HOLIDAY INN EXPRESS

PHASE II DEVELOPMENT PLANS **LOT 1 INDIAN MEADOWS FILING NO.3**

SHEET TITLE: DEVELOPMENT COVER SHEET

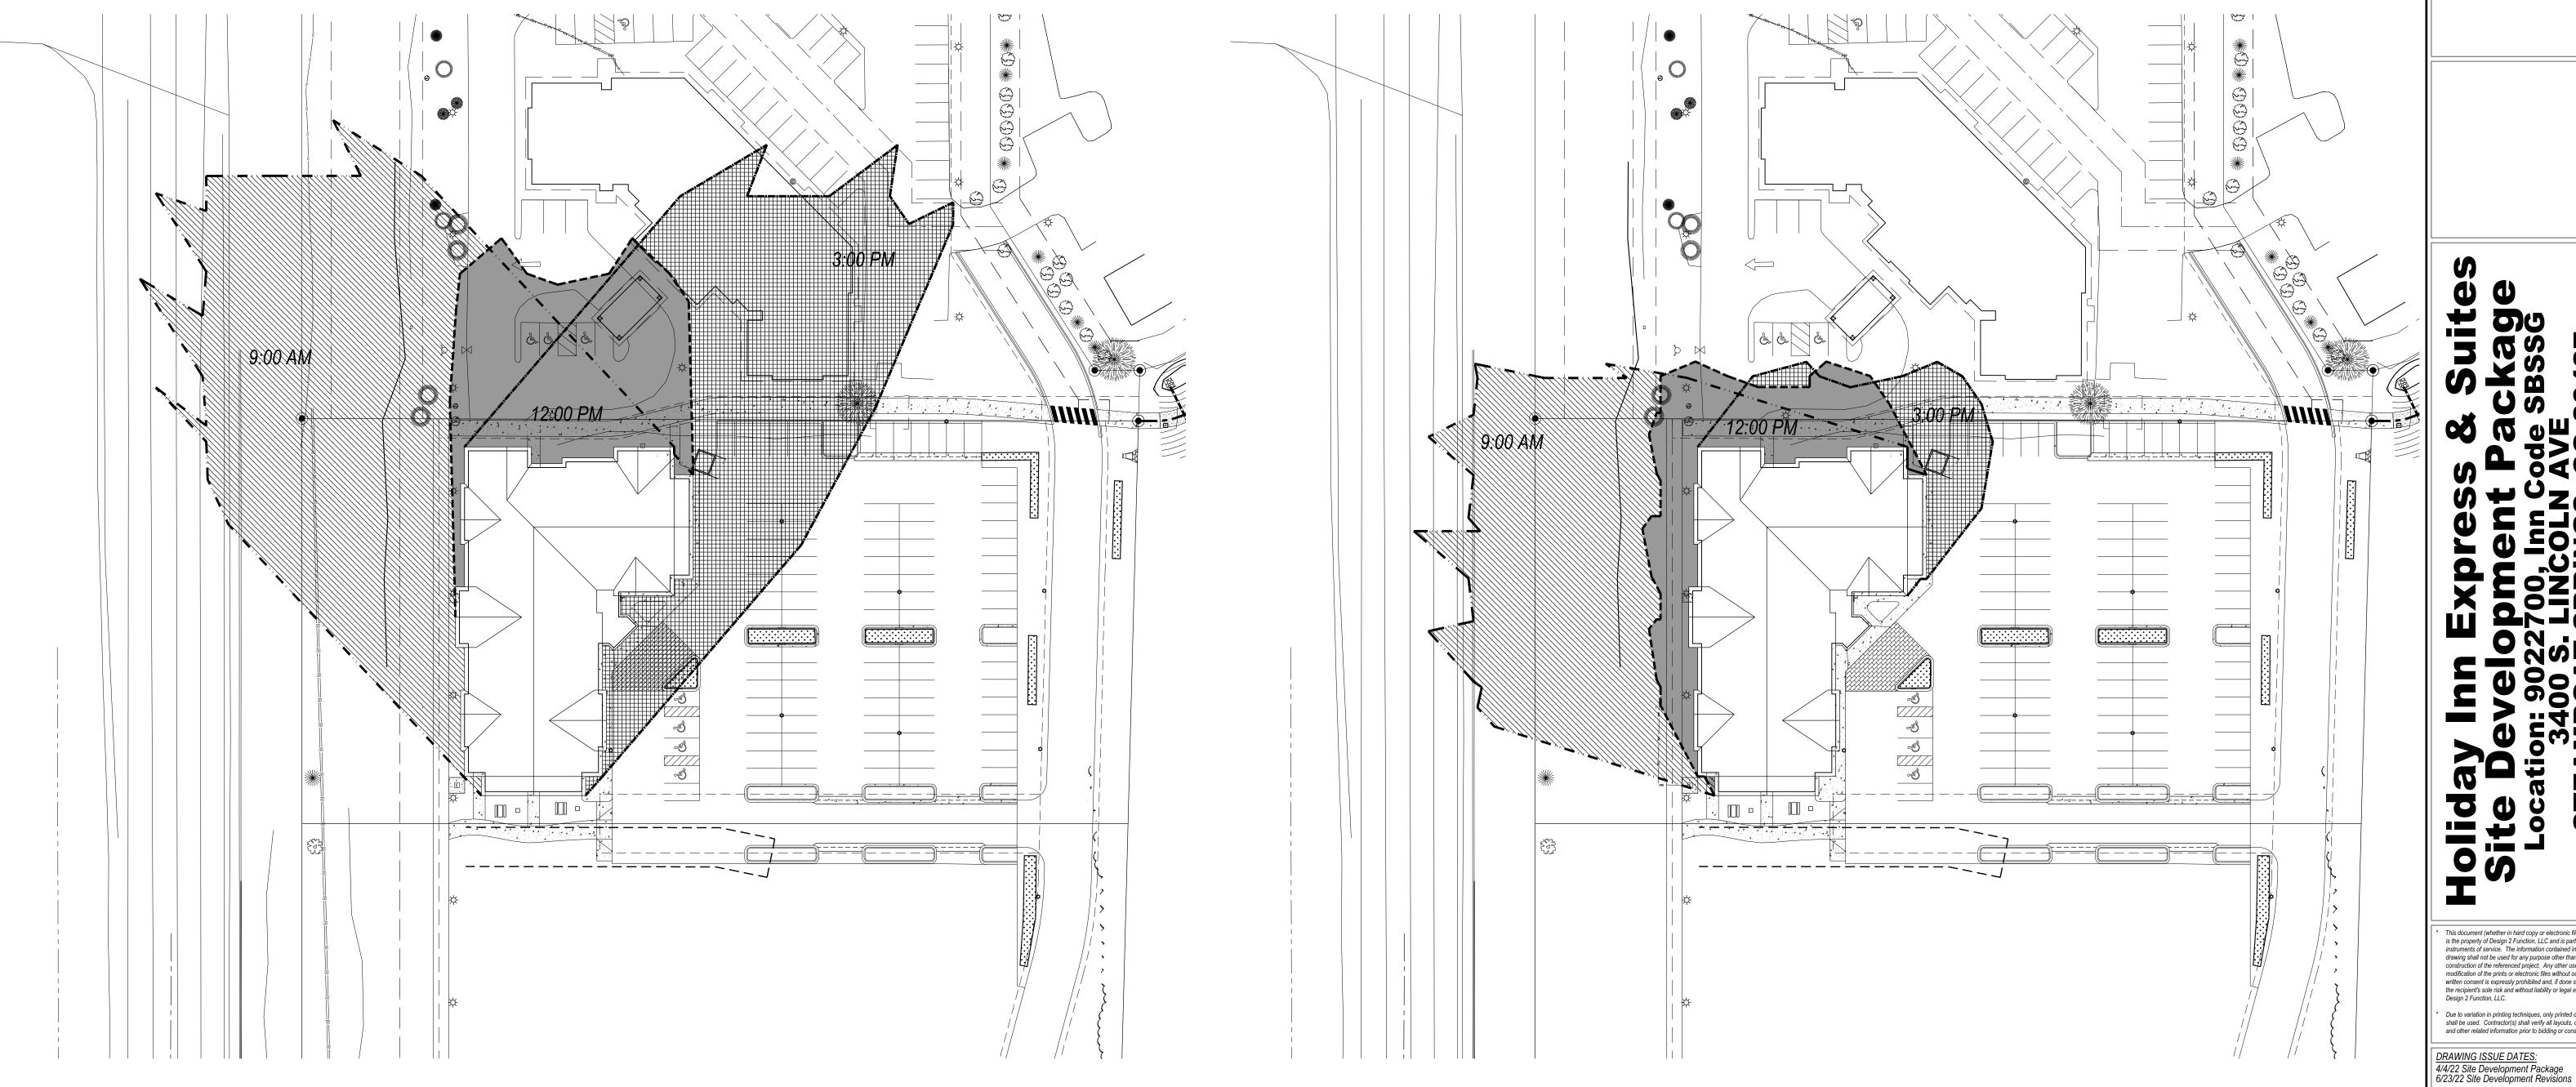
CS: how many people _proposed to occupy the staff rooms?

CS: Amend to Dormitory

DRAWN BY: SITE SHADOW PLAN

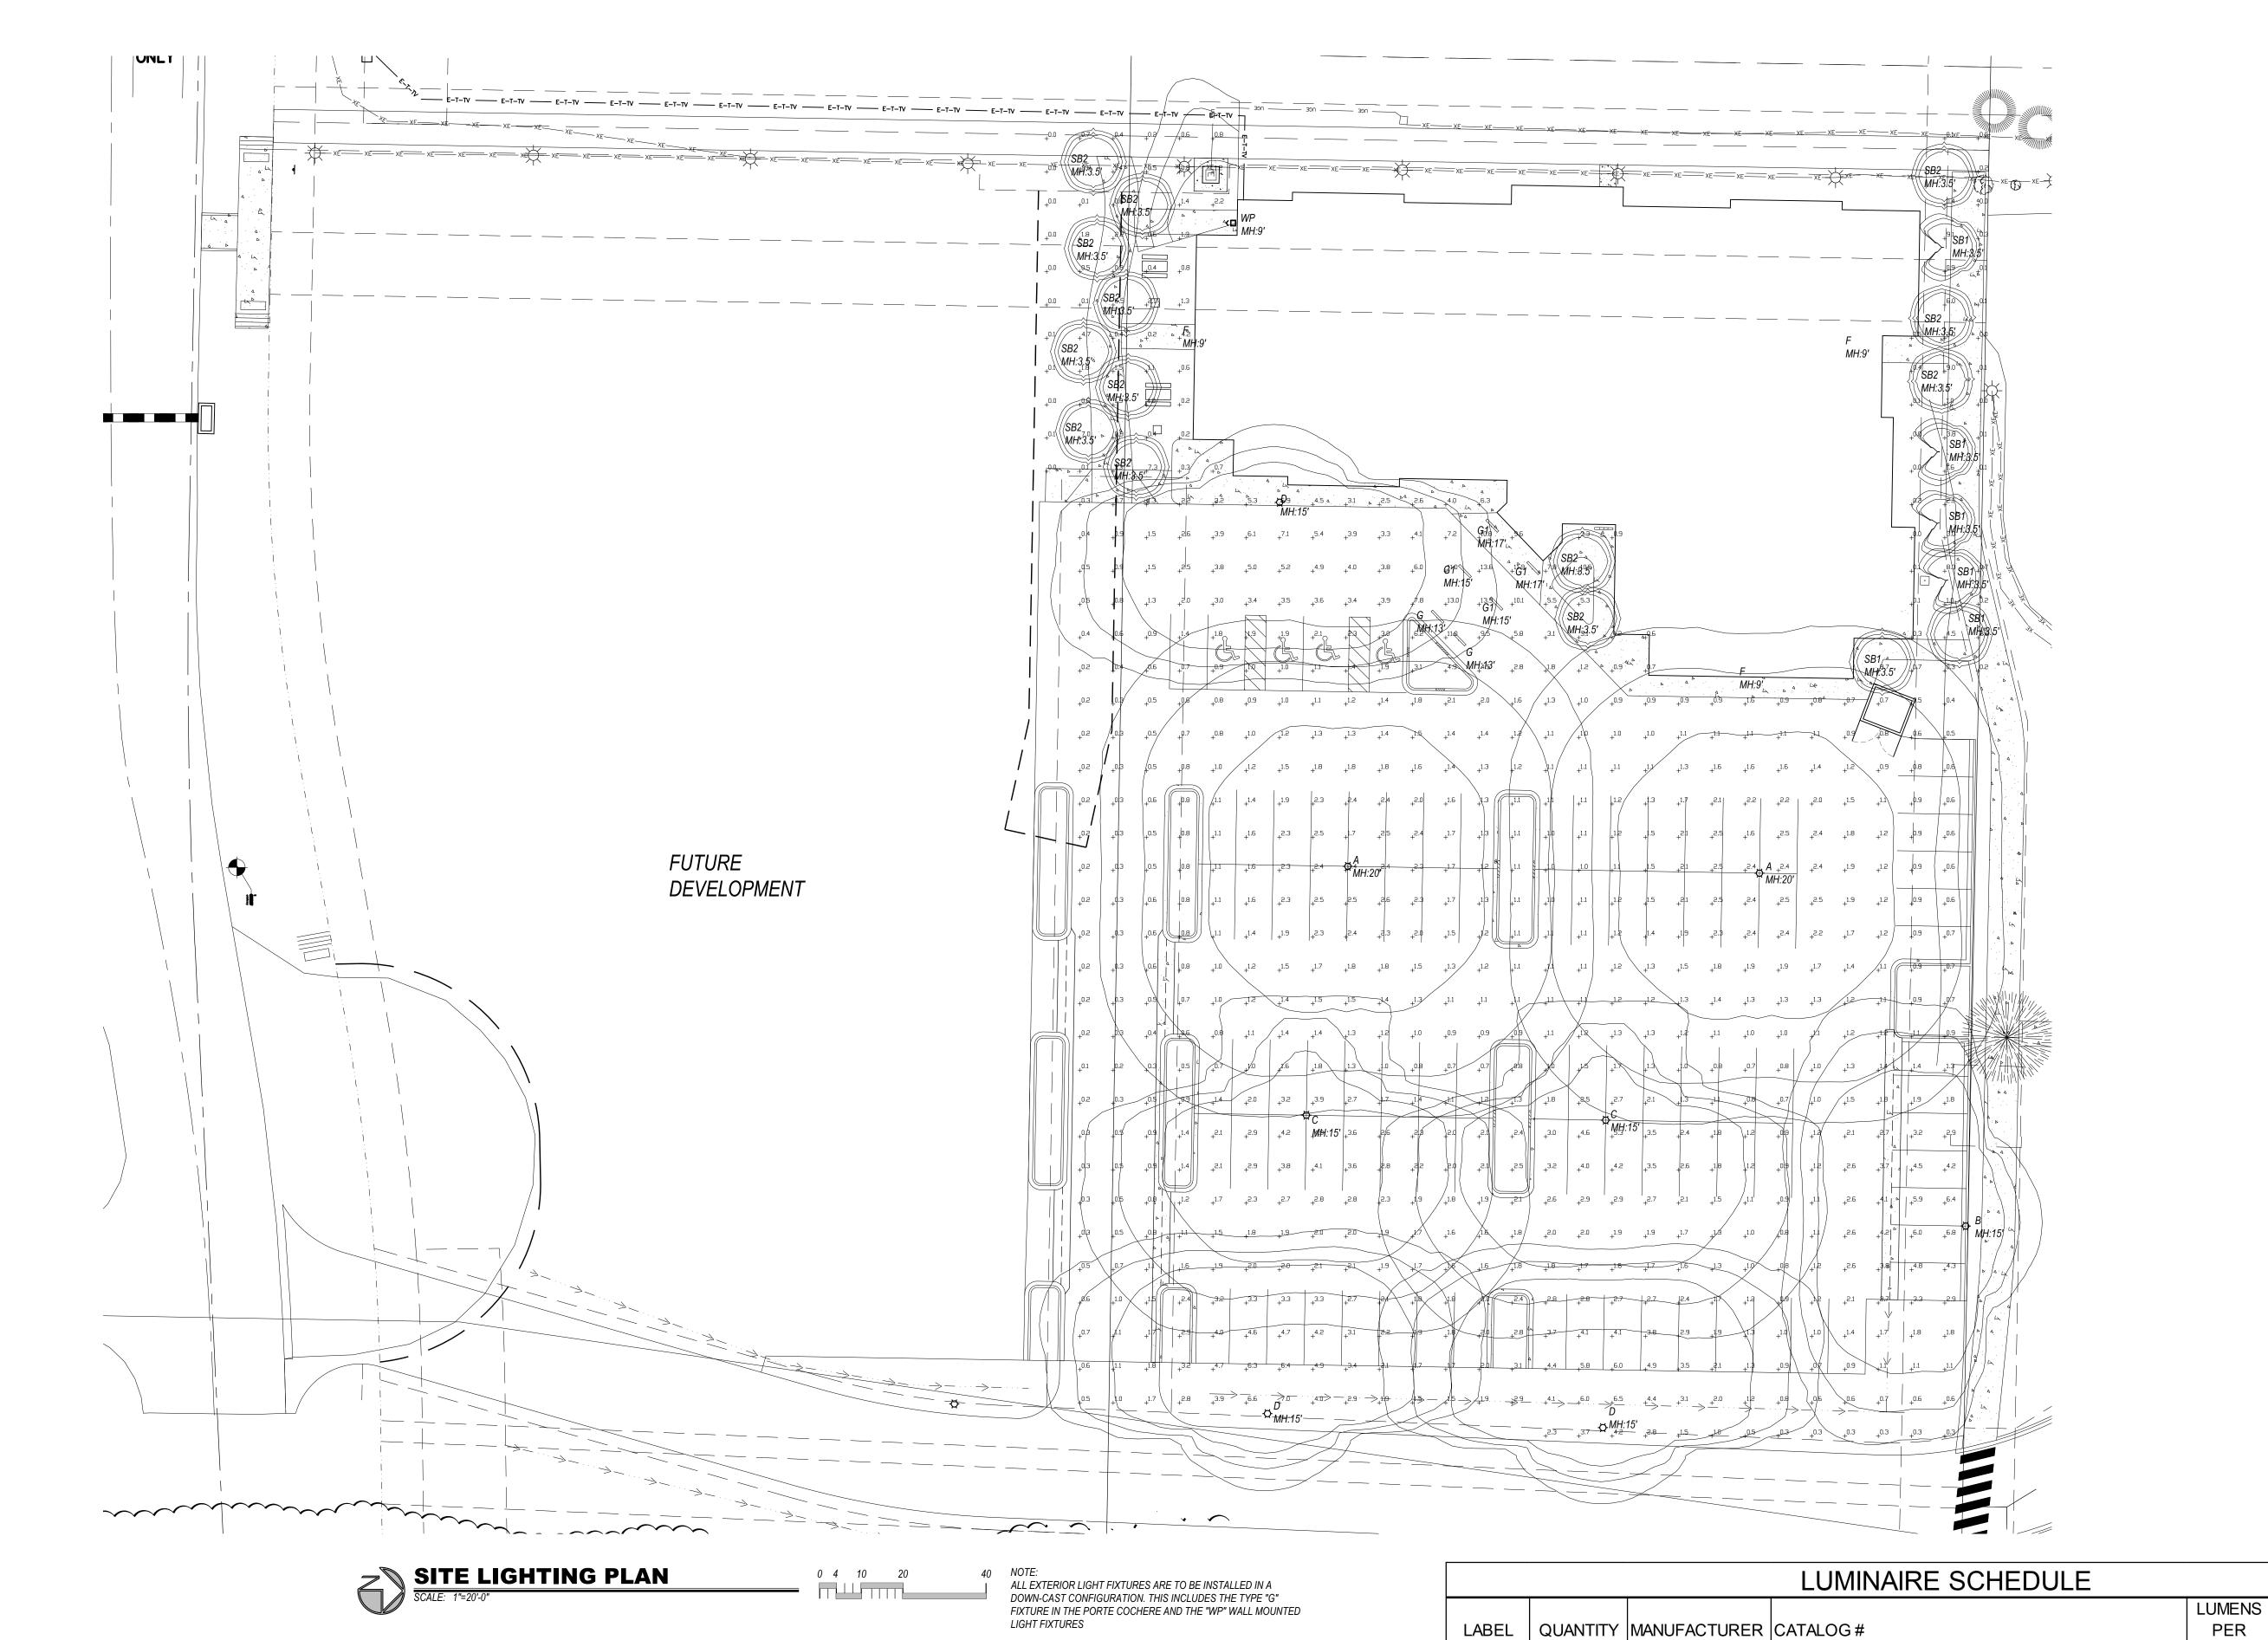
CS: what is 90 based

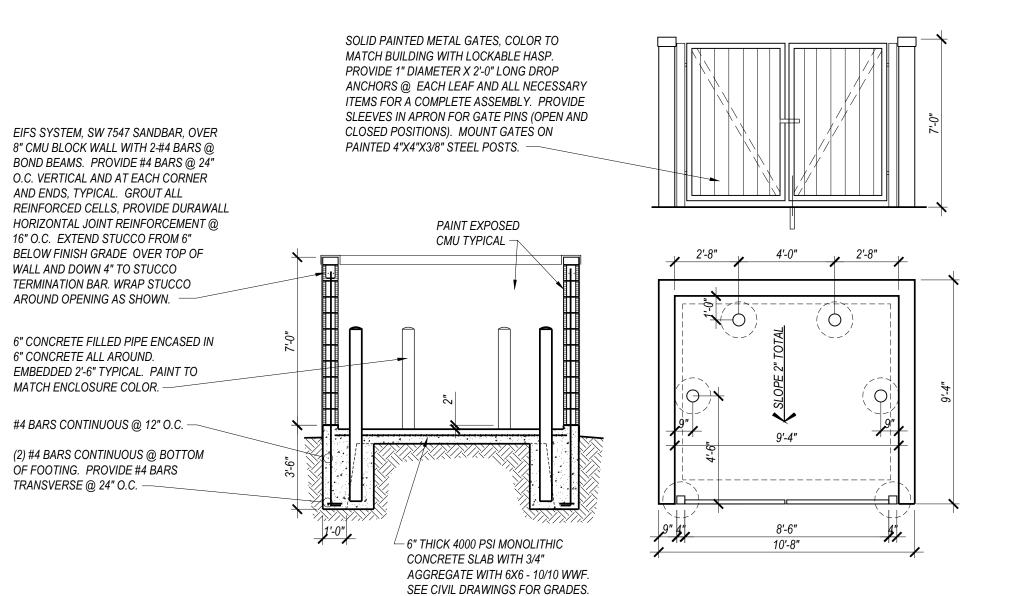
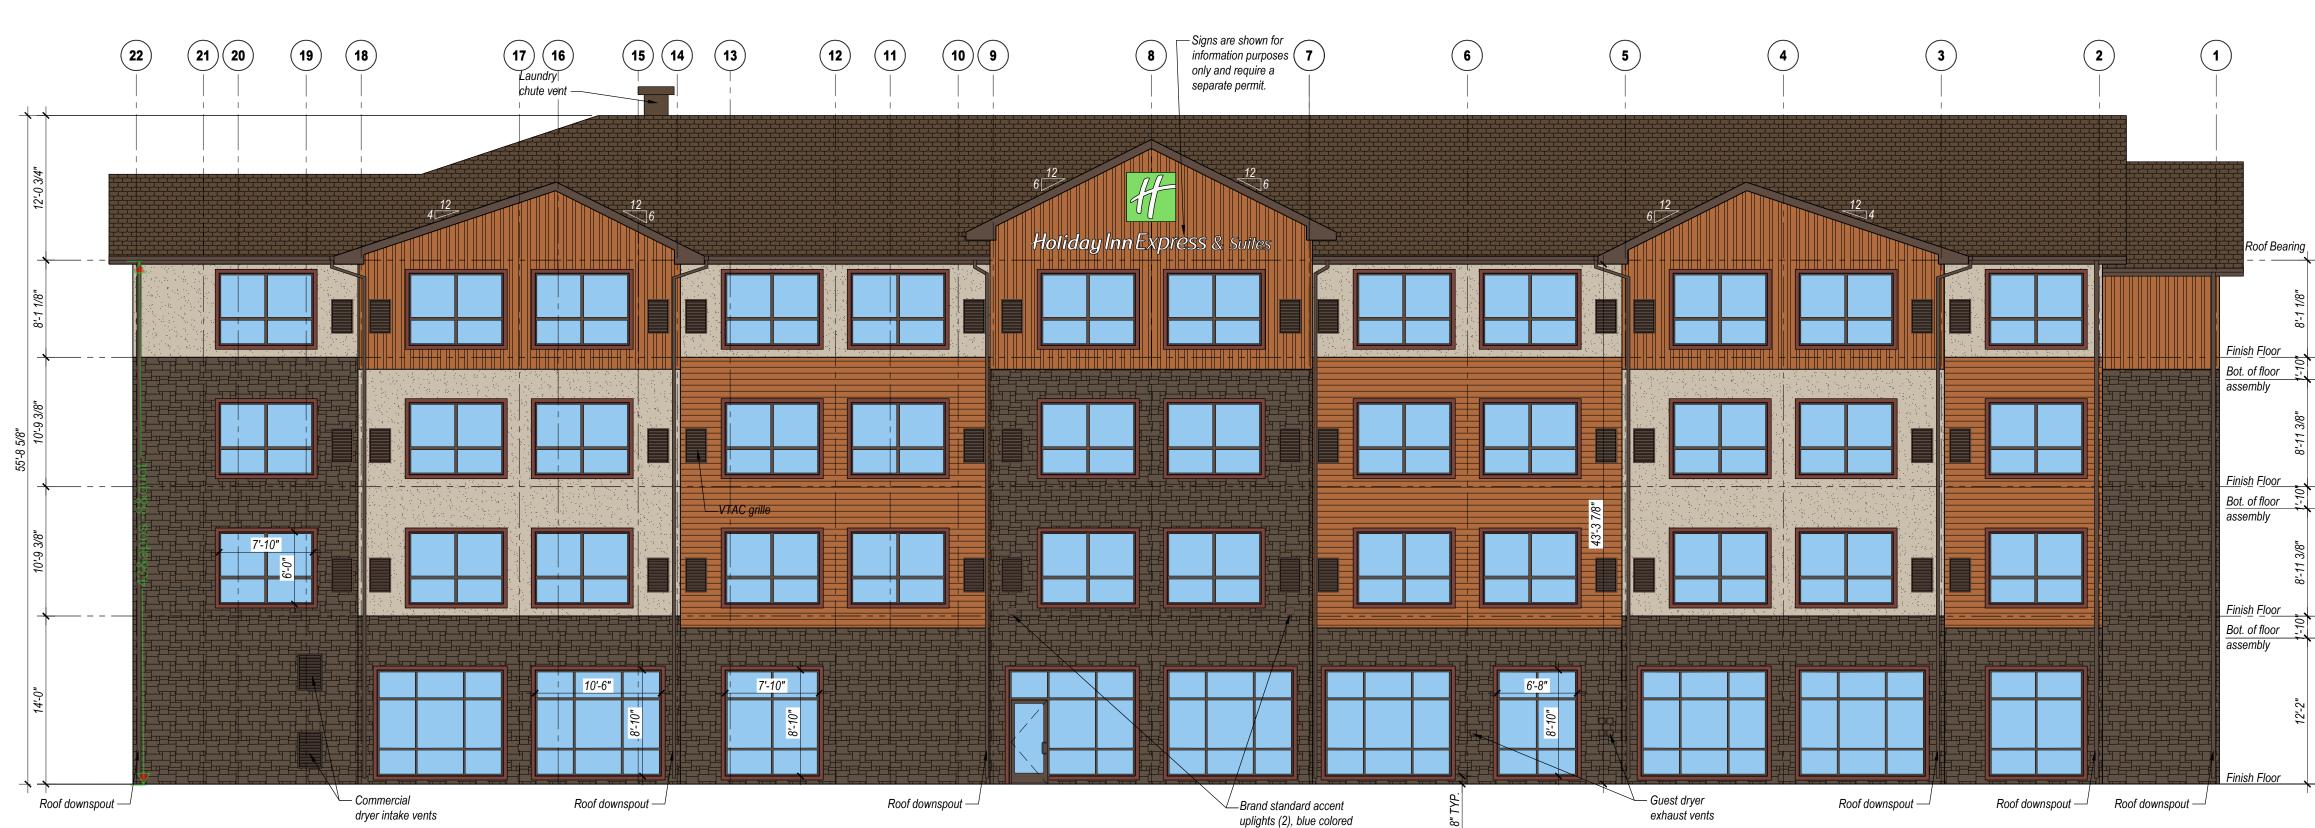
A2.2: Signage is not approved with this development plan, a separate sign permit will need to be applied for and reviewed for
